# Access Compliance Report

## Public Rights-of-Way

### (Curb Ramps)

Intersection ID: 5616	Main Street: W_W_T_HARRIS_BV	Cross Street: J_M_KEYNES_DR	Location: SW
ADA ID: AFA0AA3314A4	Ramp Type: Directional1	Initial Pass/Fail: Fail	Overall Compliance: No
			Severity Score: 13.75

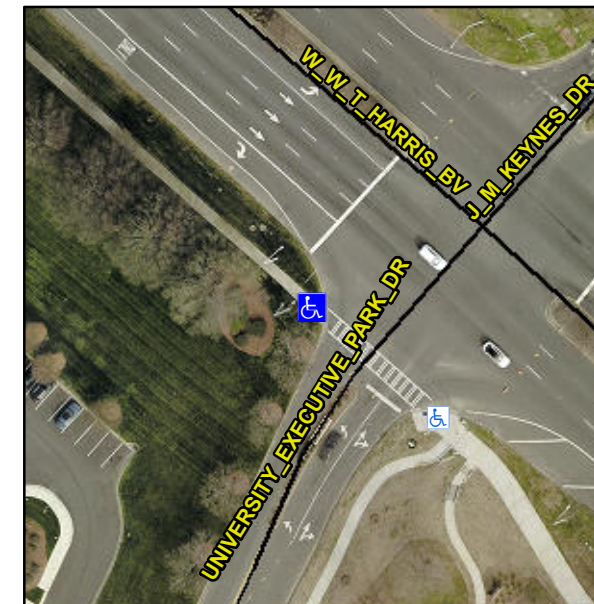
**R304.2.2, R304.5.3**

Compliance	Description	Data	Compliance	Description	Data
N/A	Ramp Length (in)	93.0	N/A	Grade Break?	N/A
Yes	Ramp Width (in)	71.0	N/A	Grade Break Slope (%)	0.0
No	Ramp Slope (%)	10.3	N/A	Grade Break XSlope (%)	0.0
No	Ramp XSlope (%)	3.2			
N/A	Flare Type LT	N/A	N/A	Flare Type RT	N/A
N/A	Flare Slope LT (%)	N/A	N/A	Flare Slope RT (%)	0.0
N/A	Flare Traversable LT?	N/A	N/A	Flare Traversable RT?	N/A
N/A	Landing Length (in)	0.0	N/A	DWS Provided?	N/A
N/A	Landing Width (in)	0.0	N/A	DWS Contrast?	N/A
N/A	Landing Slope (%)	0.0	N/A	DWS Length (in)	N/A
N/A	Landing X Slope (%)	0.0	N/A	DWS Full Width?	N/A
N/A	Landing Curb? (Y/N)	N/A	N/A	DWS Offset LT (in)	N/A
N/A	Shared Landing?	N/A	N/A	DWS Offset RT (in)	N/A
N/A	Gutter Ponding?	0.0	N/A	Gutter Slope (%)	N/A
N/A	Gutter Lip Ht (in)	0.0	N/A	Gutter X Slope (%)	N/A
N/A	Painted X Walk1?	No		Road Slope (%)	3.6
	X Walk 1 Direction	To SE		Road X Slope (%)	0.7
	X Walk 1 Width (in)	N/A		Clear Space?	N/A

**Remove & Replace Entire Ramp.**
